# Interim Reclamation and Stormwater Inspection

Operator: FULCRUM ENERGY OPERATING # 10805

Location ID: 436801

Inspection Document #: 712300073

**Photo 10.** Photo taken from the northern portion of interim area, facing east. Photo illustrates check dams are not functioning properly. It was observed that erosion (red arrows) and downhill sedimentation were occurring.

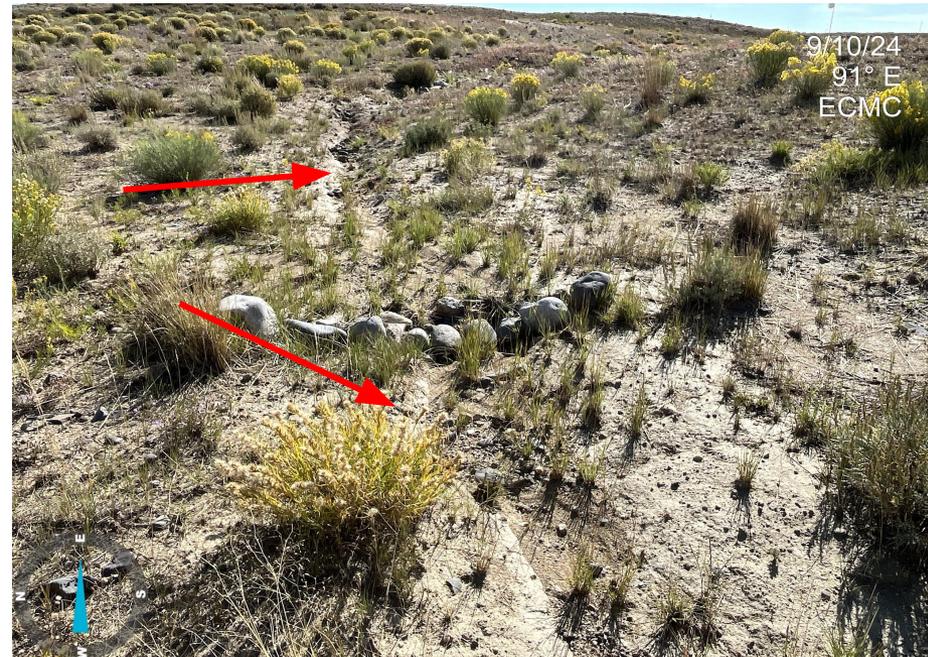
**Photo 9.** Photo taken from the eastern working pad surface, facing west. Photo illustrates erosion downhill from sediment trap revegetation of the fill slopes are in process. Operator shall continue to monitor and manage until Location reaches 1003 standards.
